Access Compliance Report

Public Rights-of-Way

(Curb Ramps)

Intersection ID: 8706	Main Street: HALSEY_ST	Cross Street: ROZZELLES_FERRY_RD	Location: S
ADA ID: 2A334392FCFA	Ramp Type: Combination1	Initial Pass/Fail: Fail	Overall Compliance: No
Codes/Mitigation Info/Possible Solution		Field Measurements/Component Compliance	
Severity Score: 46.25

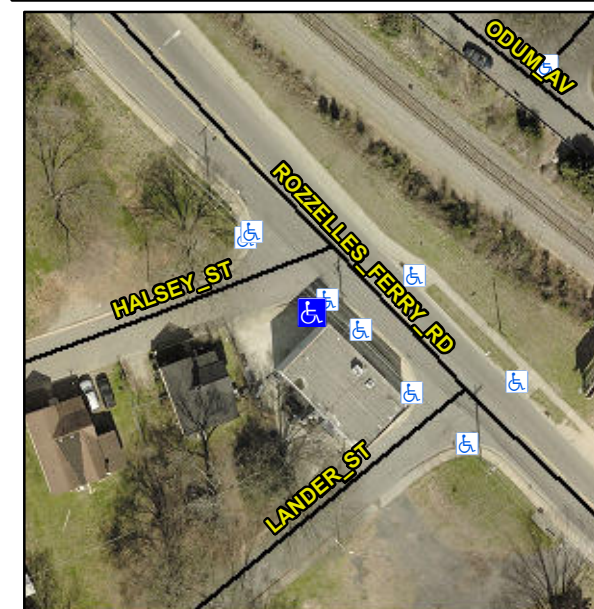
RP & LT RP < 5%

Not Found, R304.5.1, R304.5.3, R304.3.2

Remove & Replace Entire Ramp.
